<u>Lippert Components</u>, Inc. <u>Informational <u>Publication</u></u>

LIP Sheet - 0060

HYDRAULIC FULL WALL SLIDEOUT SYSTEM POWER UNIT ADDENDUM - PAGE 6

POWER UNIT - 12V DC MOTOR W/PUMP & RESERVOIR

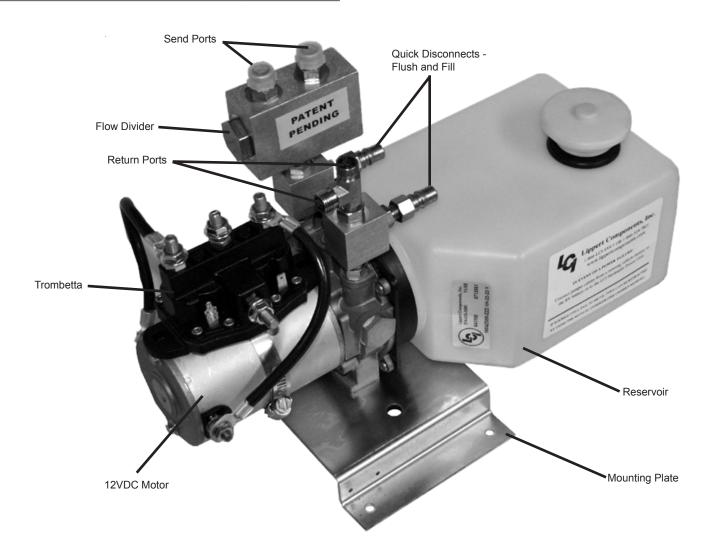
Send ports for the extention of the Full Wall Slideout System are positioned on the block with the Flow Divider. The return ports are positioned on the small square block on the retract side of the pump unit.

Page 6 of the "HYDRAULIC FULL WALL SLIDEOUT SYSTEM" represents the first version of the stand alone pump unit. This configuration showed the "Send" and "Return" ports in the opposite orientation of the pump unit shown above. The configuration above shows the current version of the "HYDRAULIC FULL WALL SLIDEOUT SYSTEM" pump unit.
